MEMORANDUM

RE: Perma Column LD (Revised Plan dated 5-15-24)
Lenhartsville Borough

DATE: June 5, 2024

Subject: Revised Plan Submission
TCG# 5577 Perma Column LD
Lenhartsville Borough, Berks County, PA

PROJECT MANAGER: LAK
 DRAWING FILE NAME: ZLD
 PLAN ORIGINATION DATE: 3-22-24
 PLAN LAST REVISED: 5-15-24
 PLAN SCALE: 1" = 40'
 PROJECT NUMBER: 5577
 SHEET NUMBER: 1.00 OF 7

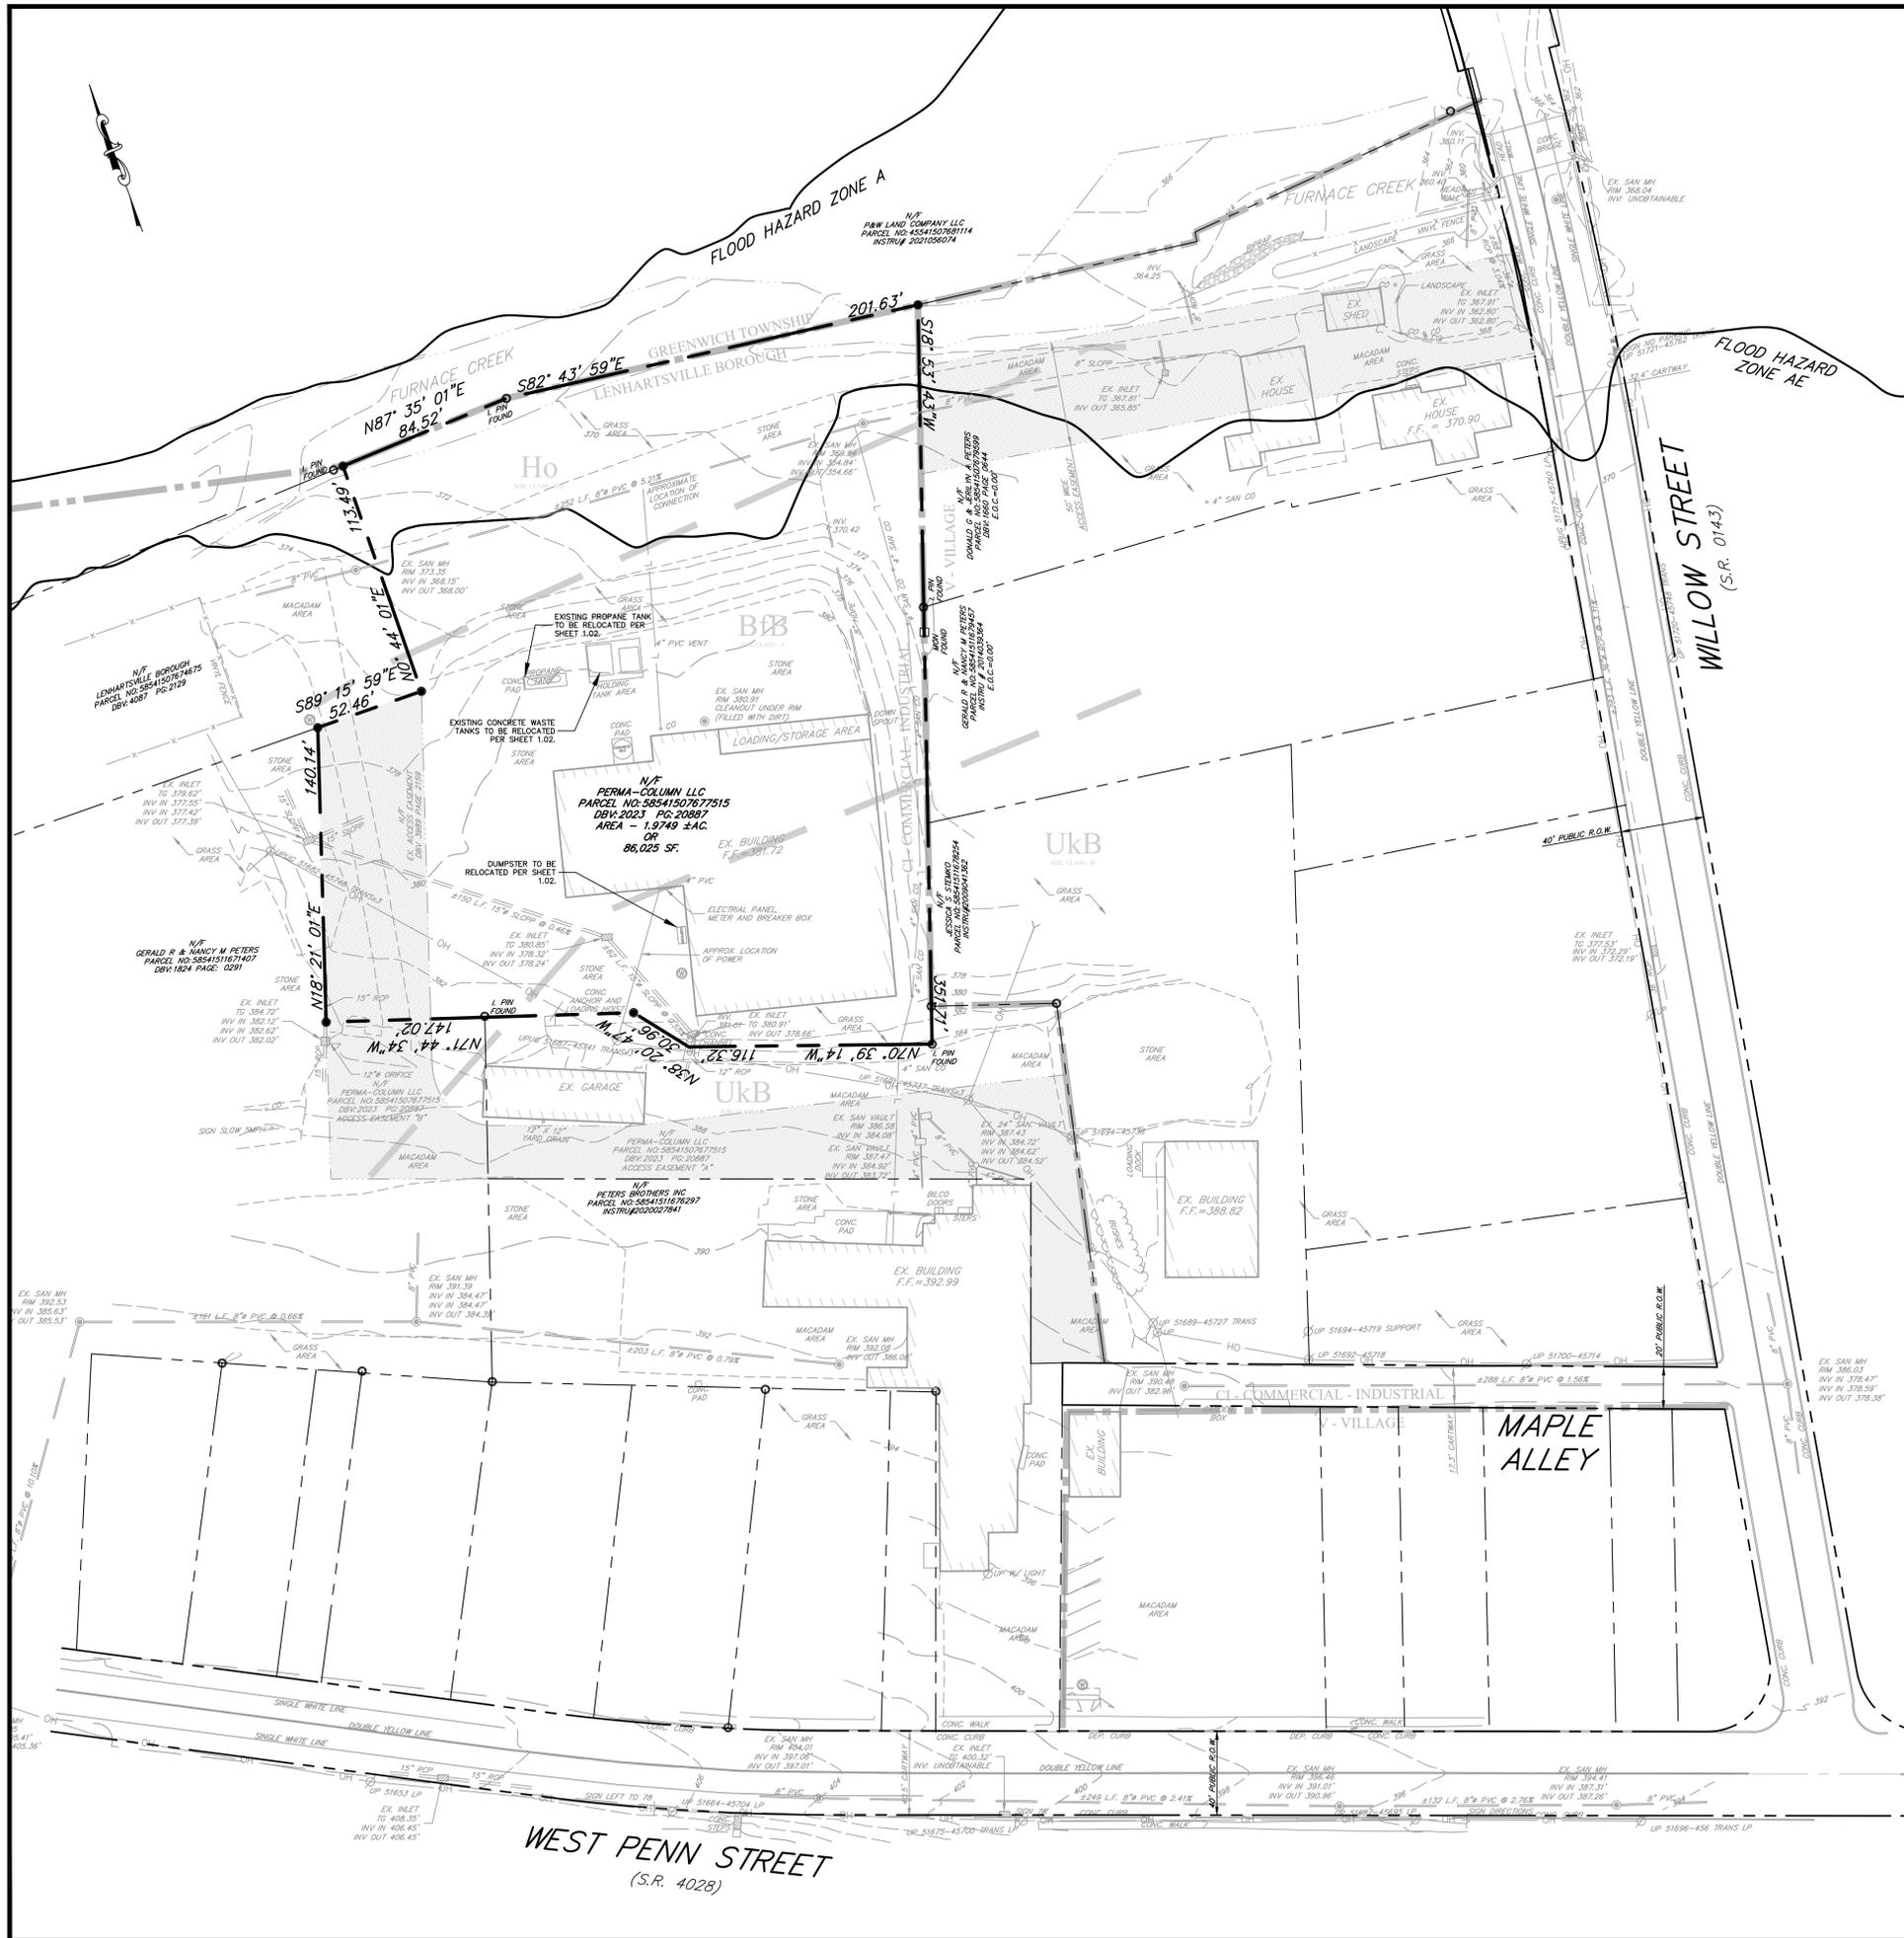
- SALDO Section 4.951: The location, size, and type of bulk storage containers shall be shown and shall be adequate to contain all wastes generated between collections.
- SALDO Section 4.953: All bulk storage areas shall be appropriately screened.
- SALDO Section 4.954: A statement of the method of frequency of refuse collection to be used shall be included on the plan.

- SALDO Section 5.12: As a condition to review a Final Plan by the County Planning Commission, the subdivider shall agree with the municipality as to the installation of all improvements shown on the Plan and required by these or by municipal regulations. Before the Record Plan may be endorsed by the County Planning Commission, the Subdivider shall submit a completed original copy of the Subdivision Improvements Agreement.

The Revised plan identifies the locations of the dumpster and concrete waste pits, and provides two plan notes, 11 and 12, to satisfy the SALDO requirements noted under Section 4.

Response comment 11. On the Crossroads Group letter states that in a “discussion with the Borough’s Engineer, due to the minor nature of the improvements associated with the project, plan note 13 has been added to sheet 1 in lieu of the need for an improvements agreement for the site”. Note 13 has been added to the revised plan.

11. Per discussion with the Borough Engineer, due the minor nature of the improvements associated with this project, plan note 13 has been added to sheet 1 in lieu of an improvements agreement for the site. The note specifies the need for proper construction & inspection of the improvements shown on the land development plans, prior to the issuance of any occupancy permits for the buildings.
12. There is no longer stormsewer proposed as part of this project, however it is noted on sheet 1.02 that all construction shall conform with appropriate local, county, and state standards.
13. Proposed plantings have been relocated to ensure a minimum of 10' from the existing and proposed sewer lines.

Table with 2 columns: Field and Value. Includes Project Manager (LAK), Drawing File Name (ZCI-STORM), Plan Origination Date (3-22-24), Plan Last Revised (5-15-24), Plan Scale (1" = 20'), Project Number (5577), and Sheet Number (1.02 OF 7).

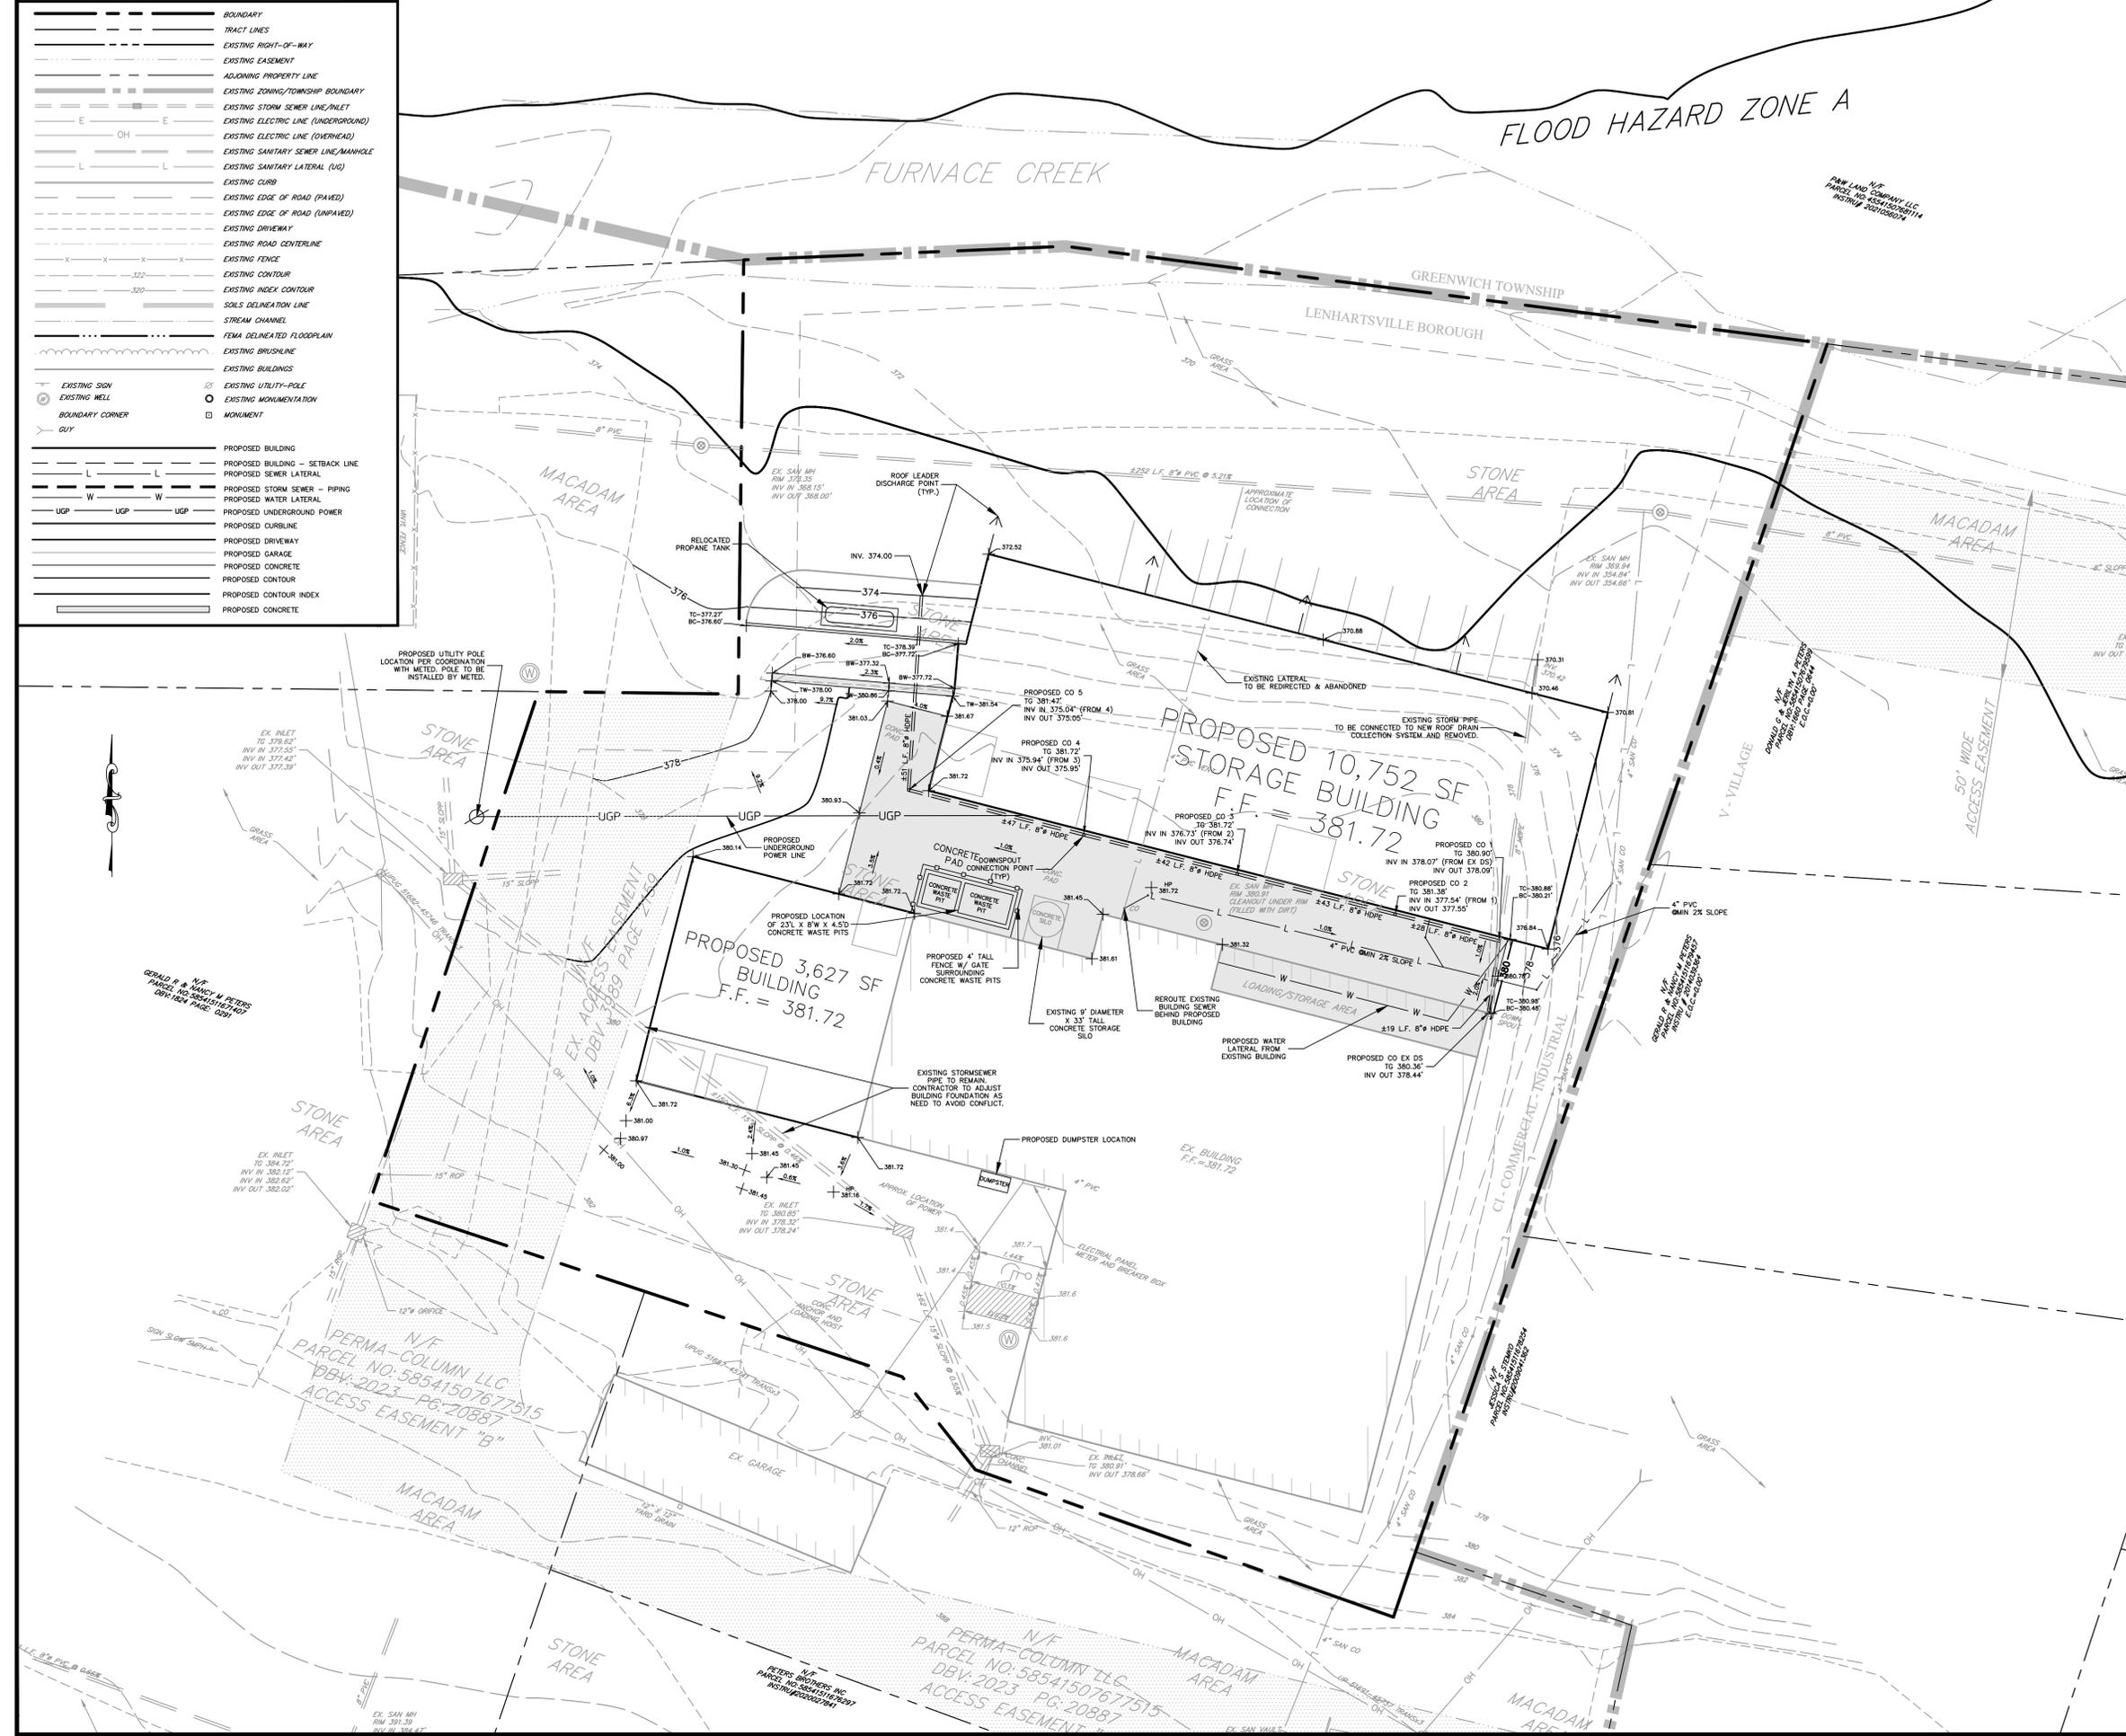
- SALDO Section 5.25: Storm sewers and related facilities shall be installed consistent with acceptable design principals.

Comment not relevant with the Revised plan. A note has been added to sheet 1.02 stating “ Existing Stormsewer Pipe to Remain. Contractor to Adjust Building Foundation as Needed to Avoid Conflict.”
